**CONTRACT
CHANGE
ORDER**

CCO No.: 002

PROJECT	PROGRAM NO.	CONTRACT NO.	SUPPL NO.	CHANGE REQUESTED BY:
Alder/Randall Street Improvement Project		P-140809		<input type="checkbox"/> OWNER <input type="checkbox"/> CONTRACTOR
TO: Rick Garabedian, JM Olvera TITLE: Storm Drain Laterals 3, 4, and 6 Revisions				OTHER ID LPPSB1L-5205(028)

(RFP-003) Storm Drain Laterals 3, 4, and 6 Revisions:

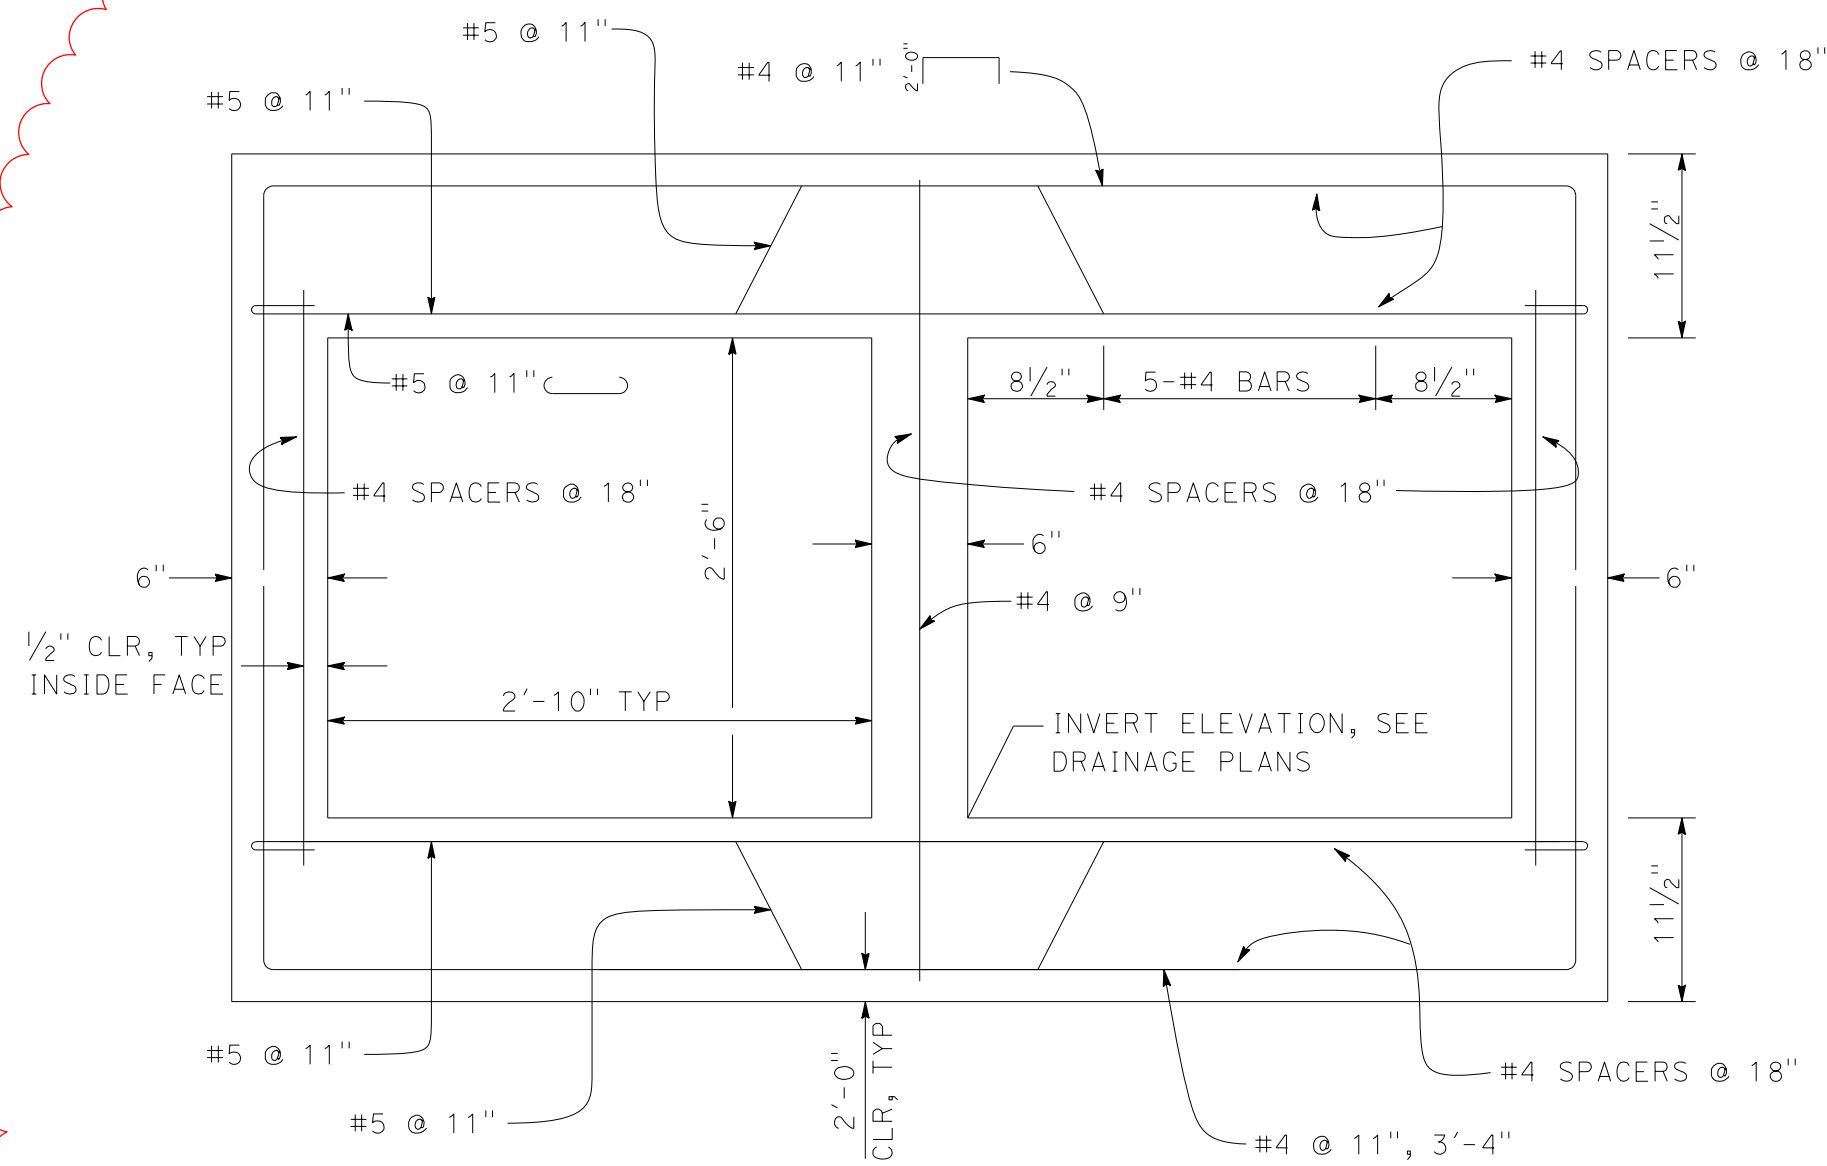
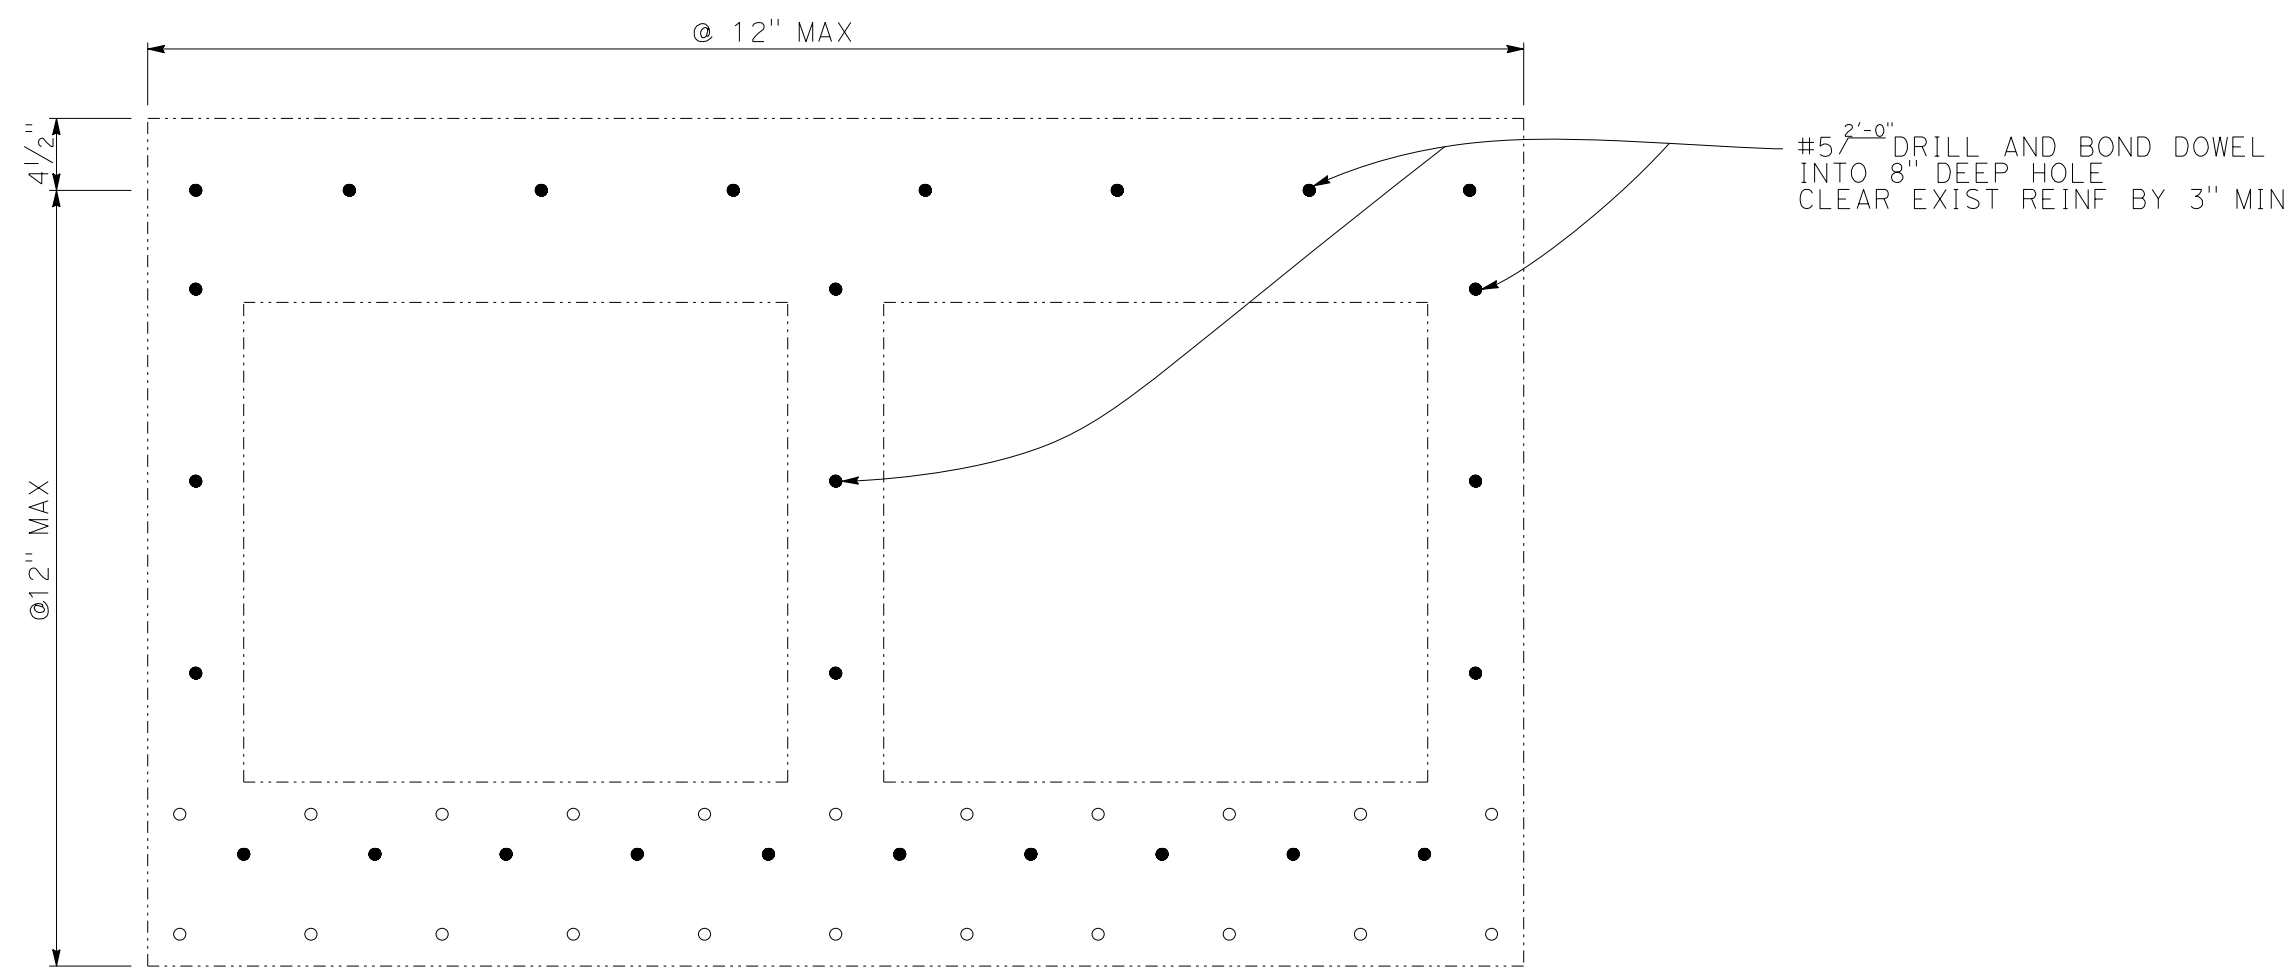
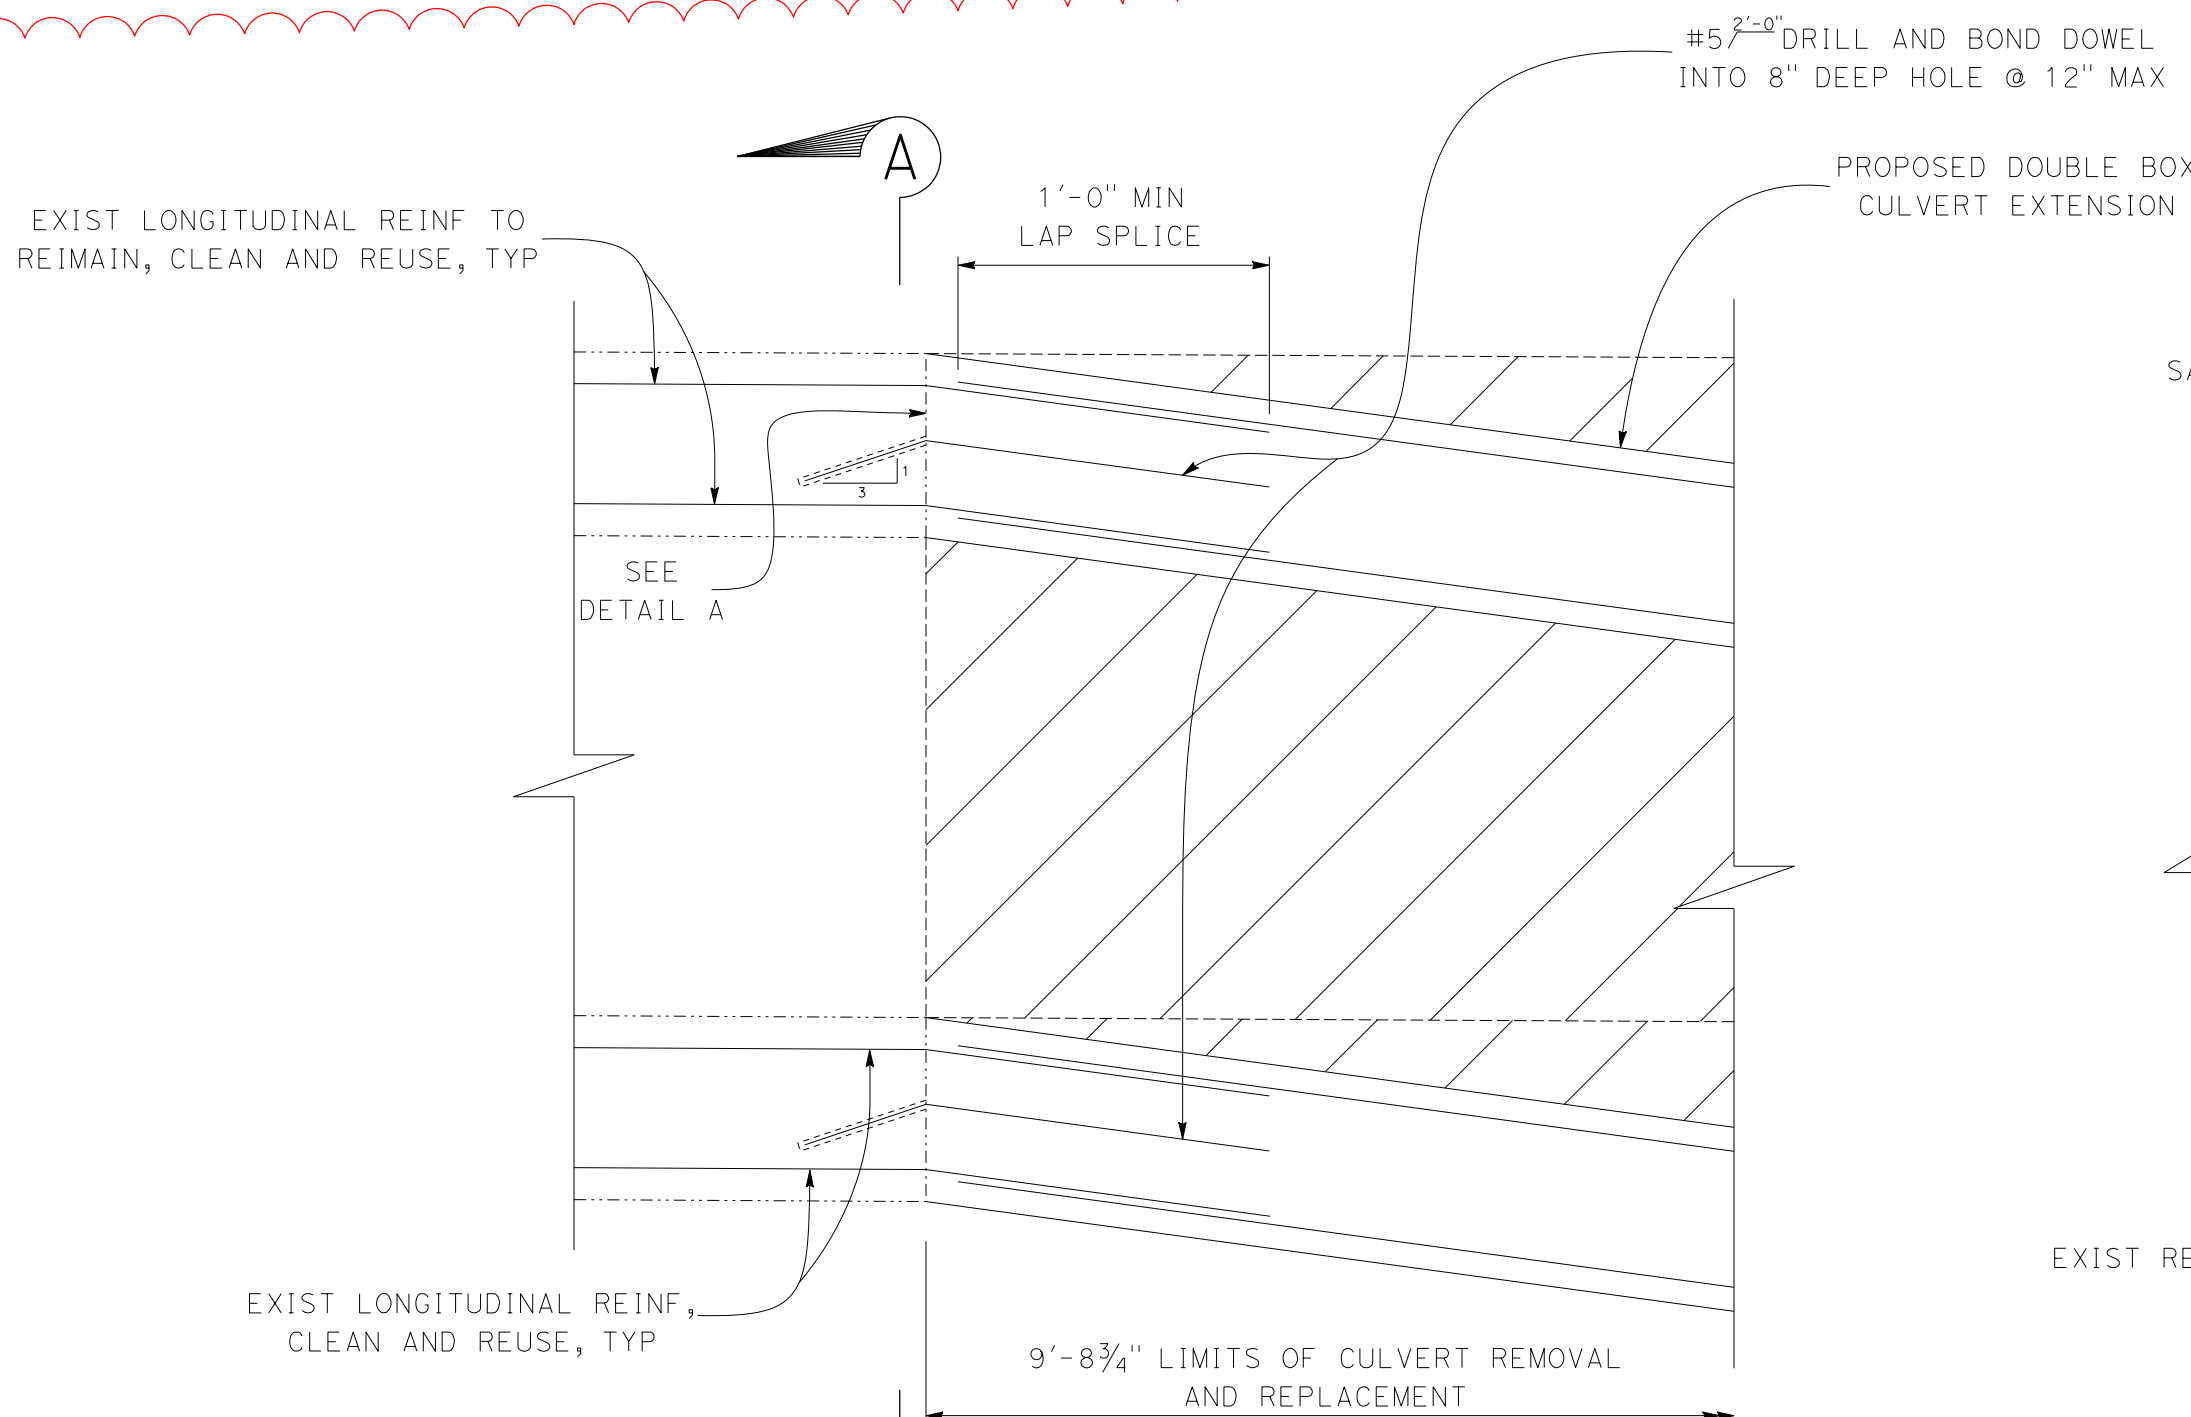
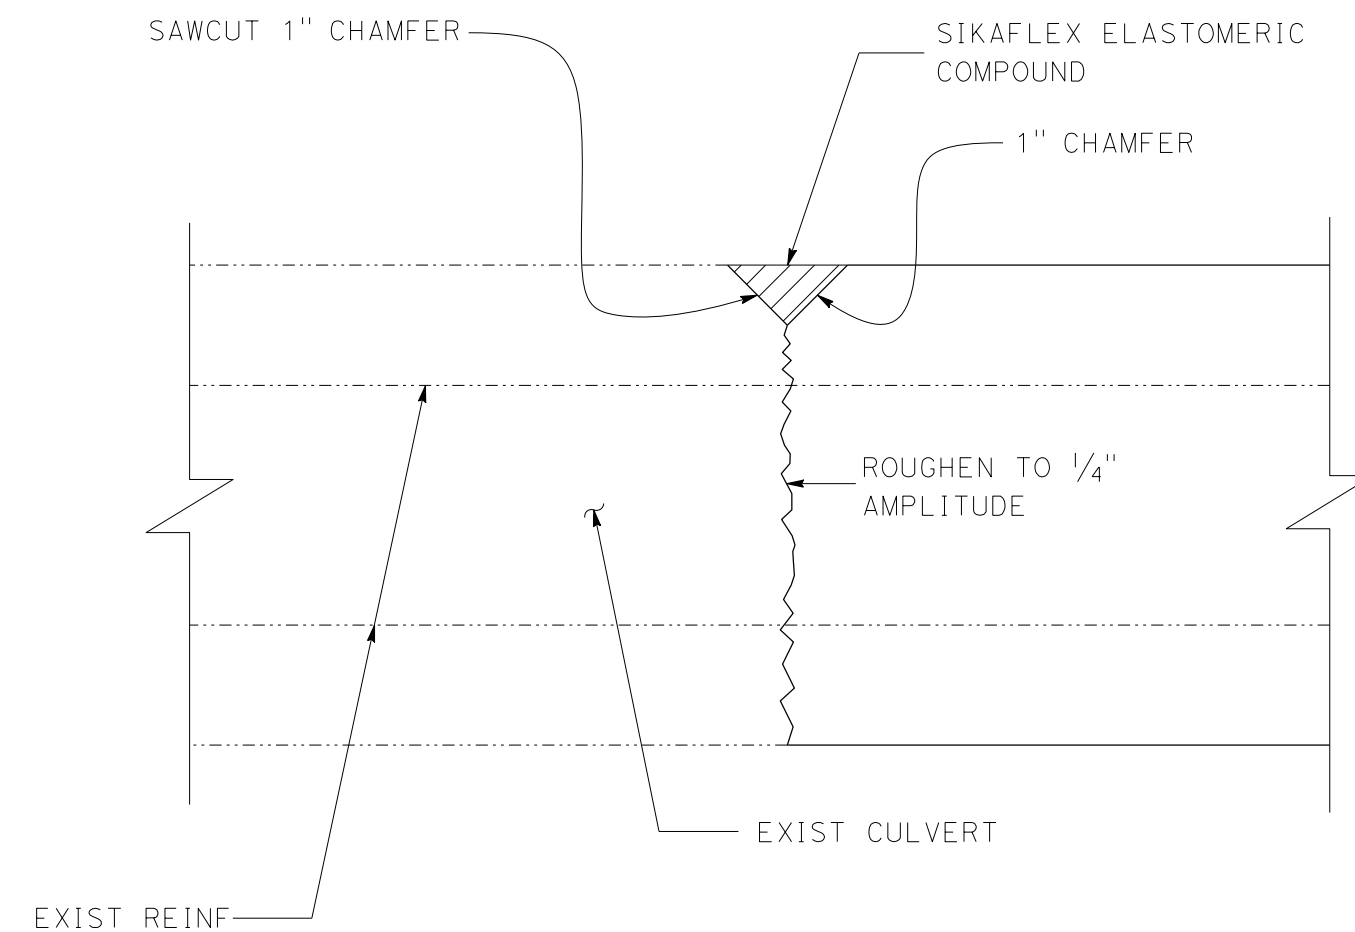
- 1) Remove a segment of the existing double RCB box at Station 132+23.32 from 10 ft right to the existing headwall as shown on Sheet 10 of 105 Rev. 01.
- 2) Construct the new Lateral 6, cast in place double RCB box at Sta. 132+23.32, from 10 ft. right to approx. 19.7 ft. right as shown on Sheet 44A of 105.
- 3) Construct Laterals 3 and 4 to revised grades as shown on Sheet 44 of 105 Rev. 01.
- 4) Construct Junction Structure “RAN” 132+23.42 per details shown on Sheet 44B of 105 (Modified from SPPWC Standard Plan 320-2).
- 5) Construct Junction Structure “RAN” 131+47.89 per details shown on Sheet 44C of 105 (Modified from SPPWC Standard Plan 320-2).
